**INSTALLATION RESTORATION PROGRAM**

**Site Investigation Report**

161st AIR REFUELING GROUP  
ARIZONA AIR NATIONAL GUARD  
SKY HARBOR INTERNATIONAL AIRPORT  
PHOENIX, ARIZONA

DATE <small>VAR. # APPROVED BY</small>	VARIANCE GRANTED AND APPLICABLE DOCUMENT	RESPONSIBLE INDIVIDUAL
11/29/90	VAR. #1 USE OF DIFFERENT GC INSTRUMENT; FIELD SAMPLING PLAN (FSP)	S. SARES
11/29/90	VAR. #2 USE OF EVACUATED GLASS VIALS FOR SOV; FSP	S. SARES
12/11/90	VAR. #3 MODIFICATION OF SITE #3 SAMPLING POINTS	S. SARES / J. WILSON
12/12/90	VAR. #4 CHANGE IN ANALYTICAL PROCEDURES & EQUIPMENT FOR ON-SITE FIELD SCREENING OF SOIL BORINGS/SAMPLES	DOUG PERRY
1/11/91	VAR. #5 CHANGE IN PIEZO. / WELL SAND PACK	S. SARES
1/11/91	VAR. #6 CHANGE IN SOIL CLASSIFICATION AND SAMPLING FORMS	S. SARES
1/16/91	VAR. #7 SAMPLE COLLECTION/SUBMIT	S. SARES
1/17/91	VAR. #8 CHANGE IN ANALYTE TESTS	ORRALL FERGUSON
1/24/91	VAR. #9 SITE A, DELETION OF <sup>SOL</sup> BORING SAMPLES	S. SARES
2/13/91	VAR. #10 GROUNDWATER SAMPLING PURGE PROCEDURE	S. SARES
4/9/91	VAR. #11 GROUNDWATER SAMPLING OF 2 IN. PIEZOMETER	S. SARES

By SWS Date 11 DEC 90 Subject SKETCH MAP OF AREA AROUND Sheet No 1 of       
Chkd By      Date      SITE NO 3 ADAPTED FROM BASE ENG. DRAWING Proj. No 409321

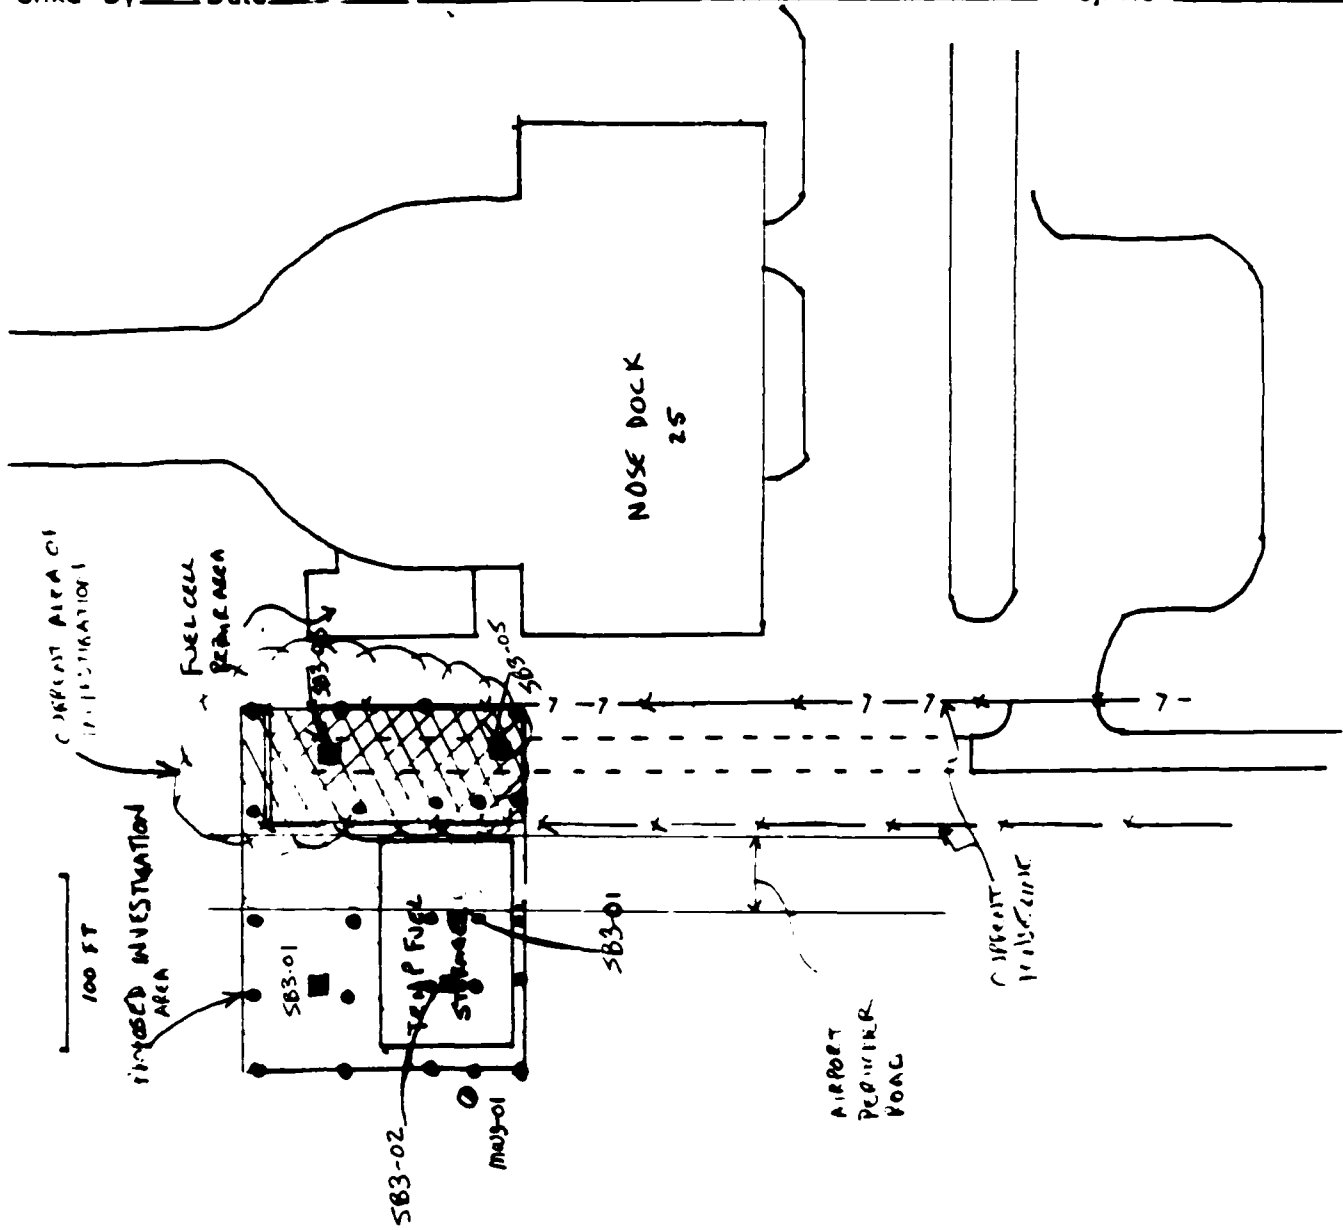
TIRE FIELD SAMPLING PLAN WAS PREPARED UTILIZING "EXISTING" BLUE LINE DRAWINGS FROM TIRE BASE. IN PARTICULAR, SITE 3 WAS A FUEL STORAGE AREA BELIEVED TO HAVE BEEN WITHIN A CYCLONE FENCED AREA (ATTACHMENT 1). RECENT UTILITY CLEARANCE ACTIVITIES DISCLOSED A 1972 MAP SHOWING THE FUEL STORAGE AREA ABOUT 150 FT. WEST OF LEASE LINE. THE PURPOSE OF THIS VARIANCE IS TO REQUEST MODIFICATION OF SAMPLING AREAS TO THOSE SHOWN ON ATTACHMENT 2. NO SCOPE CHANGE IS ENVISIONED. THE SAME SAMPLING POINTS OCCUR BUT IN SLIGHTLY DIFFERENT LOCATION TO ADEQUATELY CHARACTERIZE THE SITE.

FIGURE 5-4a

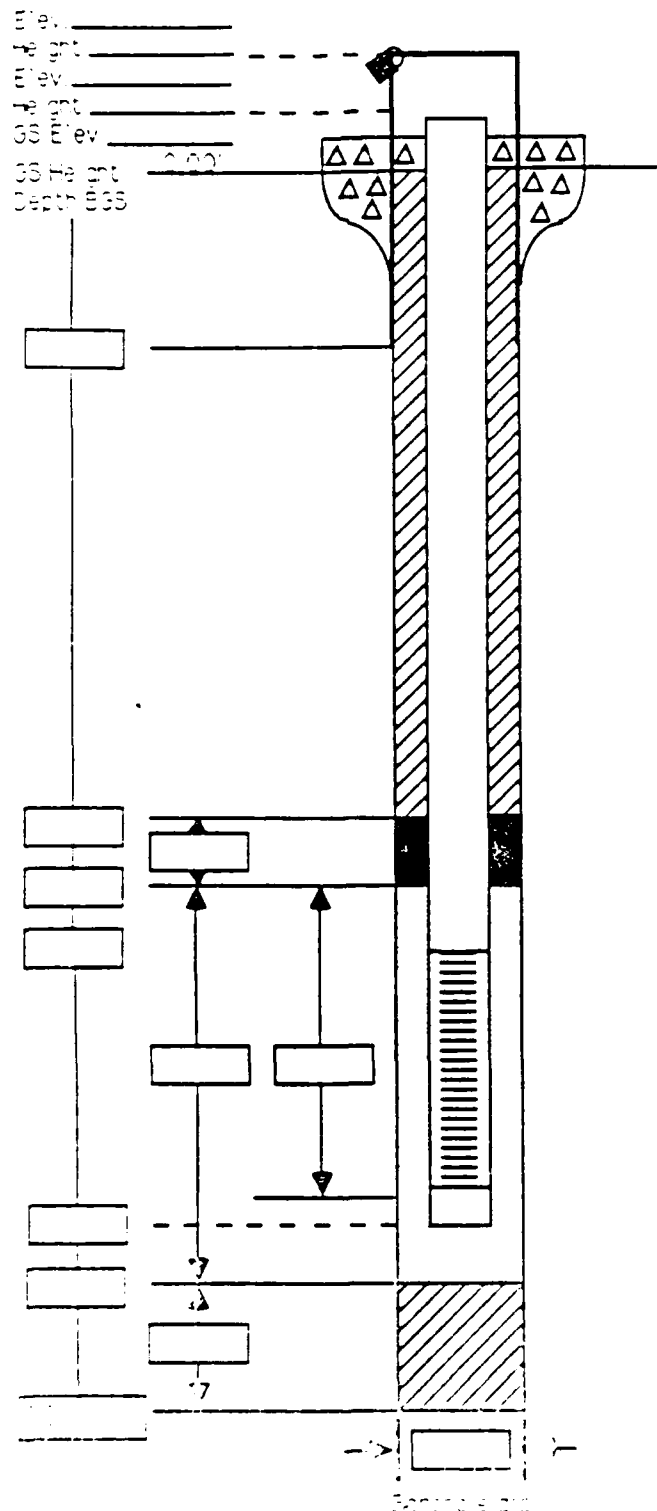
Substitute the following field description forms for forms described in work Plans. The "new" forms are specified in HAZWOP Guidance documents as preferred to maintain program consistency. The replacement forms contain the same or more information as the work plan forms.

THE FSP IS MODIFIED AS FOLLOWS: PG. 5-17, SECT. 5.5.2, 2ND SENTENCE IS MODIFIED TO READ, "THE INFORMATION RECORDED ON THE BORING LOG FORM (FIGURE 5-3a) WILL ALSO INCLUDE ----"; PG. 5-24, SECT. 5.5.3.2, LAST SENTENCE, REPLACE REFERENCE TO "FIGURE 5-4" WITH "FIGURES 5-4a AND 5-4b"; PG. 5-25, SECT. 5.5.4, LAST PARA., 2ND SENTENCE, IS MODIFIED AS FOLLOWS: "FIELD TURBIDITY AND OTHER DEVELOPMENT RESULTS WILL BE REPORTED ON FIGURES 5-4c AND 5-4d FOR EACH WRM." PG. 5-30, SECT. 5.7.4.2, LAST SENTENCE, IS MODIFIED BY REPLACING, "FIGURE 5-6" WITH "FIGURES 5-6a AND 5-6b."
